Technical Memo

To Jim Kelly, PE and Katy Shores (City of Arlington)
From: Madison Wright, PE (SCJ Alliance)
Date: October 16, 2024 6-7pm
Project: 180th Corridor
Subject 180th Corridor Public Zoom Meeting

Layout 1 - Straight Alignment

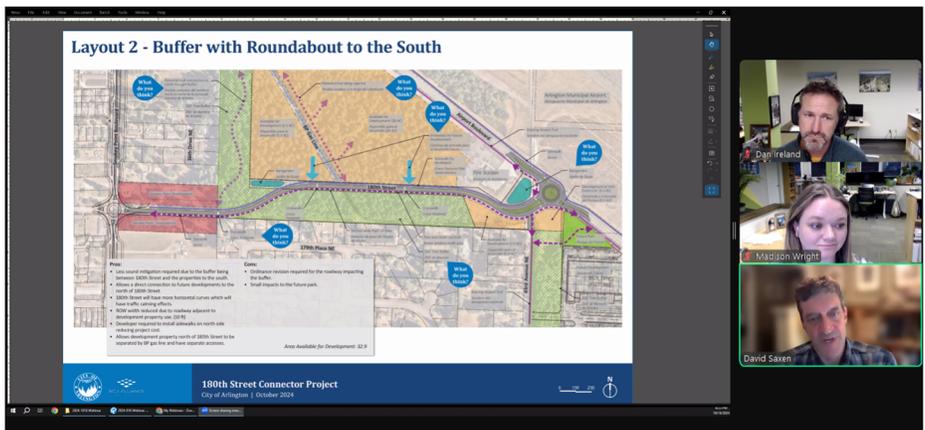
So what I am hearing is that the 5' wide trail is in the north side of the road. Does that mean that the road is up against the fence line?

Not a great idea when there could be freight trucks driving by our homes.

There would be approximately a 8-15 ft buffer for layout 1.
